World Forum for Harmonization of Vehicle Regulations

Regulation No. 59 (Replacement silencing systems)

Proposal for the 02 series of amendments to Regulation No. 59

Submitted by the Informal Working Group on UN Regulations Nos. 51 and 59¹

Arrangements of approval marks

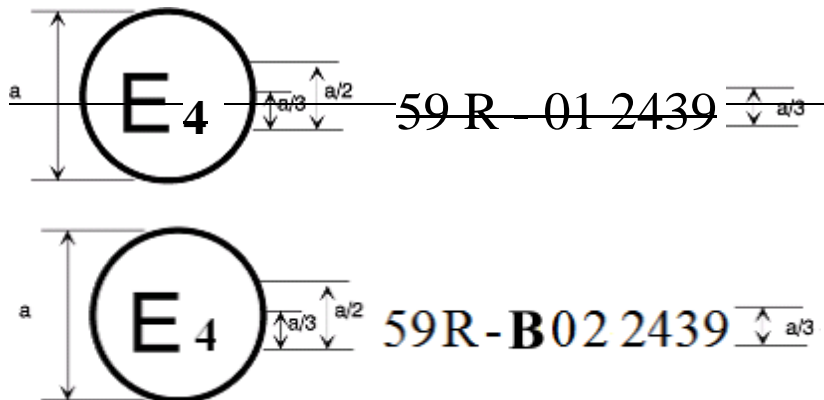
The above approval mark affixed to a component of **exhaust** silencing system shows that the **exhaust** replacement silencing system type concerned has been approved in the Netherlands (E4) pursuant to UN Regulation No. 59 under approval number ~~01~~22439.

The character **B** symbolizes that the approval was granted for the limit values according to phase 2 as given in 6.2.2. of the 03 series of amendments of the UN Regulation No. 51, followed by two ~~The first two~~ digits of the approval number that indicate that the approval was granted in accordance with the requirements of UN Regulation No. 59 as amended by the ~~01~~2 series of amendments.
